## Planning Commission Staff Report

August 9, 2017  
Item 6.c.

- SUBJECT:** P17-0356 & PUD-124
- APPLICANT:** Dale Morris, Valley Brokers
- PROPERTY OWNER:** Frank Abboud
- PURPOSE:** Work Session to review and receive comments on: (1) rezoning three properties from RM-4,000 (Multi-Family Residential) to PUD-HDR (Planned Unit Development – High Density Residential); and (2) a PUD Development Plan to: (a) retain and expand three existing homes; and (b) construct three, two-story single-family homes on the eastern portion of the project site, and associated site improvements.

- LOCATIONS:** 4664, 4676, and 4682 Augustine Street
- GENERAL PLAN:** High Density Residential
- SPECIFIC PLAN:** Downtown Specific Plan – High Density Residential

**Figure 1: Site Plan**

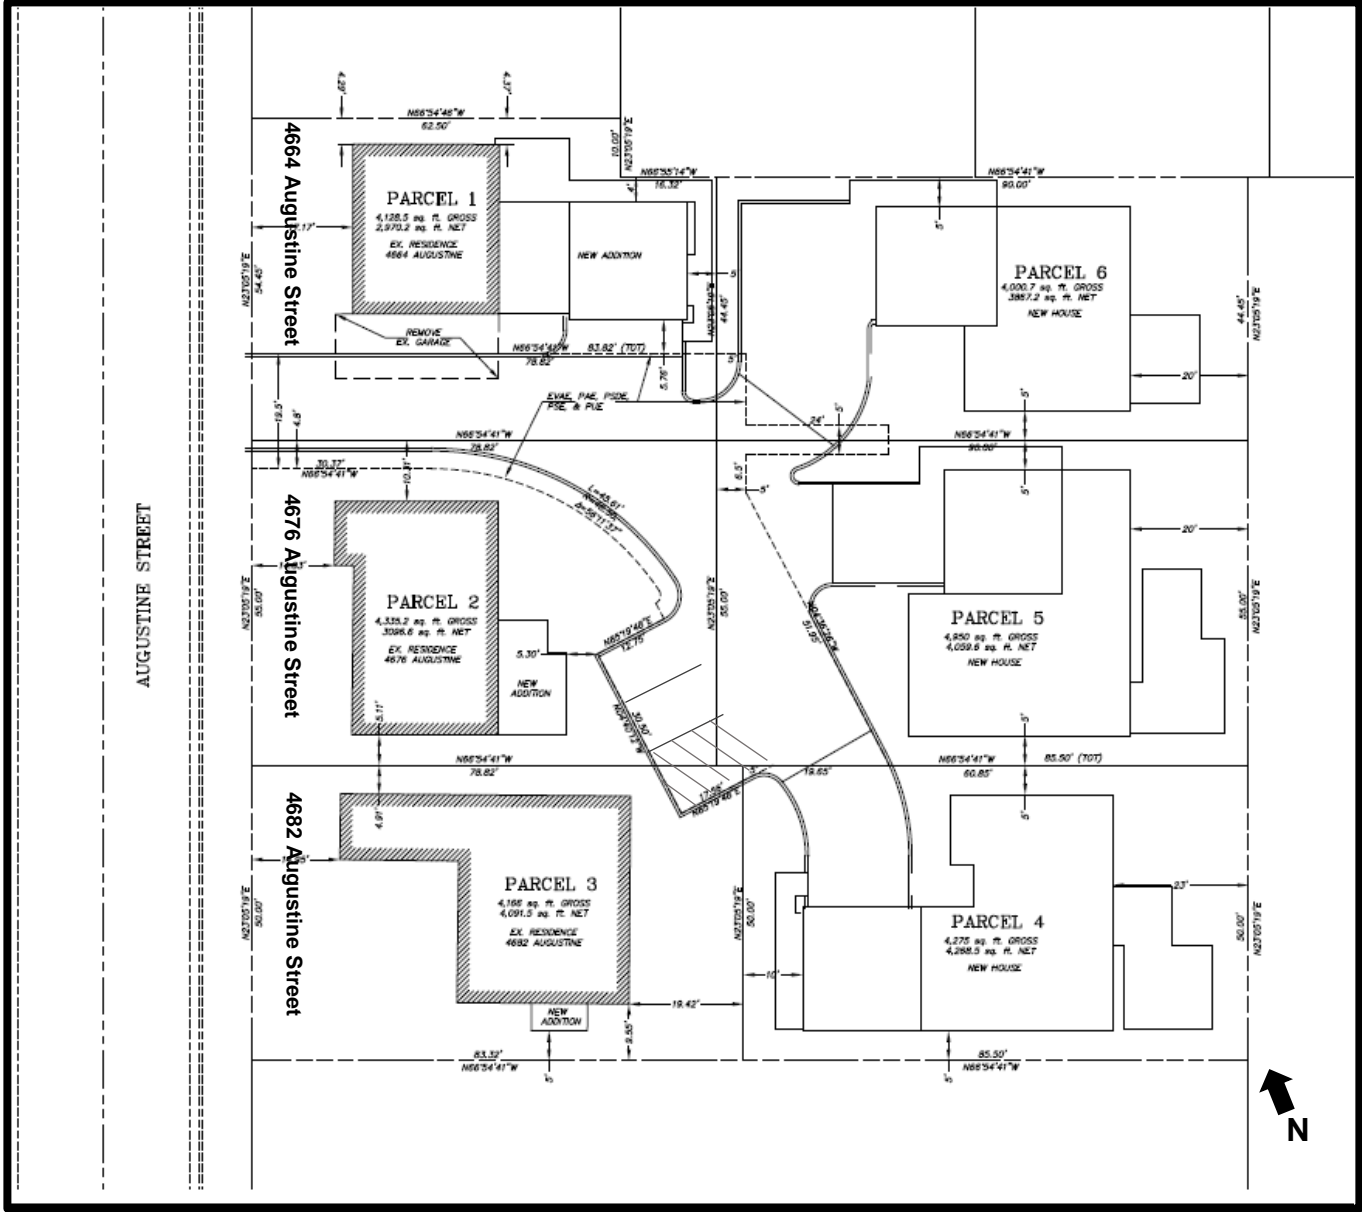
Staff seeks the Commission's comments regarding the street design and overall pedestrian experience. Staff believes that the site layout provides adequate vehicular access, but lacks good pedestrian access. The private drive aisle would not be a public street and pedestrian connection is limited to one side of the drive aisle. Staff believes that the pedestrian pathway should be a minimum of 5 feet, with attractive landscaping along the interior border of the pathway, to allow for simultaneous pedestrian and bicycle travel.

Staff also seeks the Commission's comments regarding the layout of Lot 6 and the proposed garage addition on Lot 1, as the proposed improvements may result in impacts to the neighbor's trees, which are off-site and heritage-sized. Furthermore, staff would like comments from the Commission on whether the applicant should pursue a smaller house design or alternative layout on Lot 6 to retain the on-site heritage-sized tree (No. 24 in Exhibit C).

**Figure 3: Tree Survey**

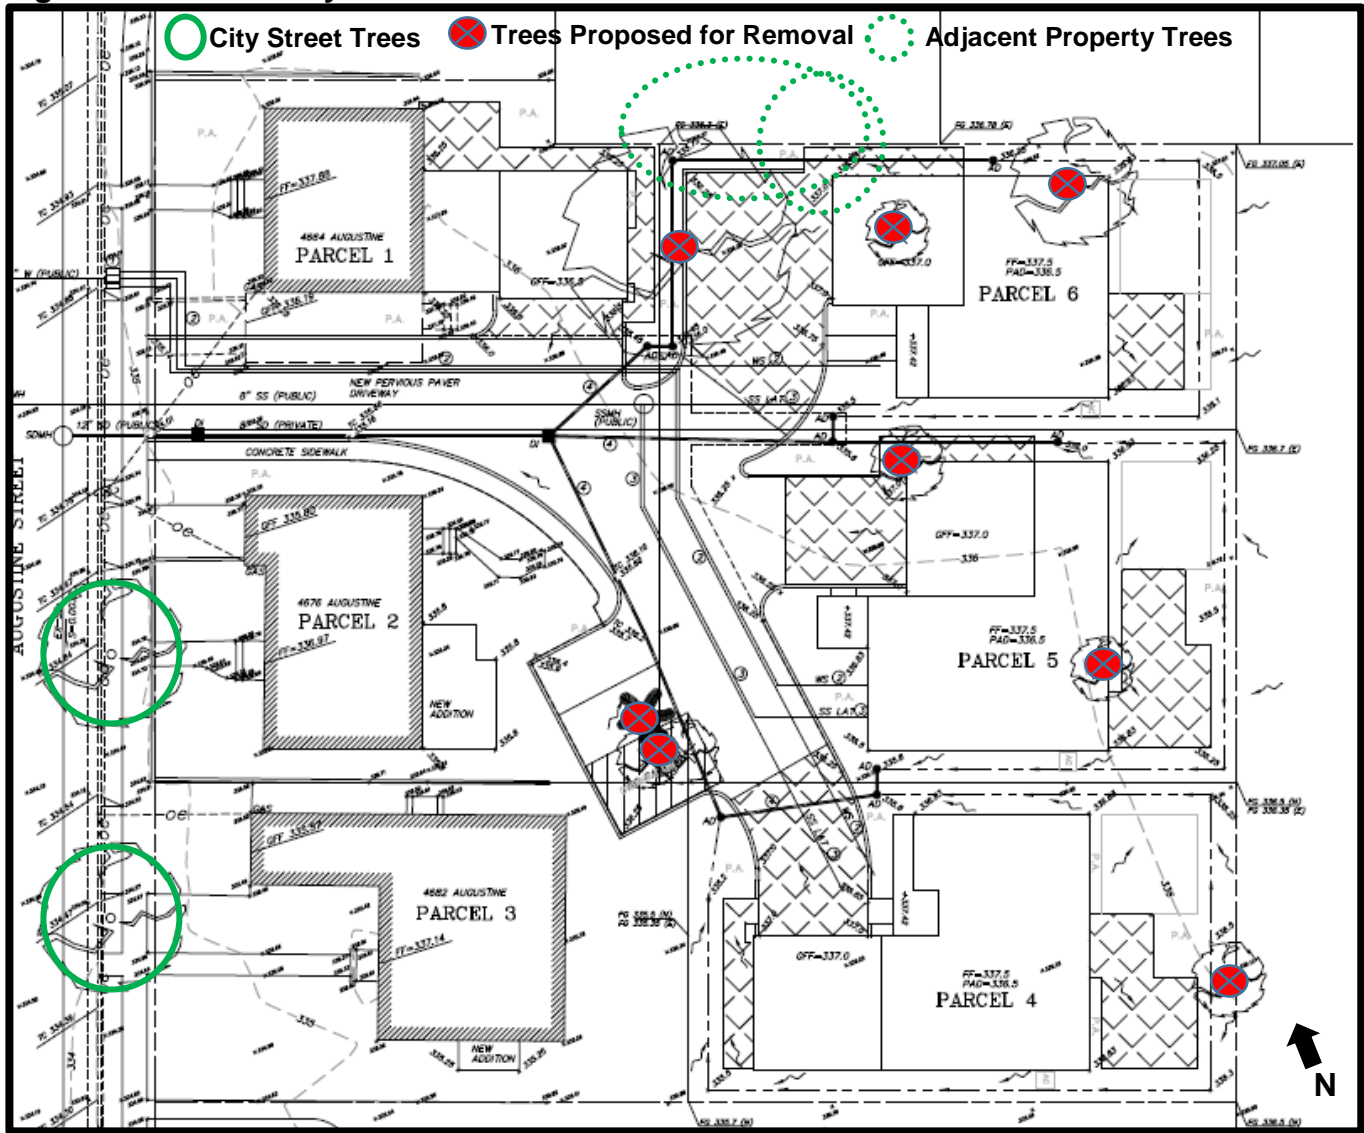
Due to conflicts with building pad locations and/or within areas where grading and/or infrastructure is proposed, all eight on-site trees, including the heritage-sized tree, are proposed for removal (see Figure 3). The tree report indicates that the two heritage-sized trees located at 278 West Angela Street would require exploratory trenching to determine if they could be preserved. If trenching reveals that the roots of the tree(s) will be significantly damaged, the tree(s) would have to be removed or the construction and/or on-site improvements for Lots 1 (new garage) and 6 (new home) would need to be modified to ensure survival of the tree(s). Staff does not support the removal of off-site trees and will work with the applicant to preserve off-site trees prior to returning to the Planning Commission for a formal recommendation of the project to City Council. The two City street trees are not proposed for removal.
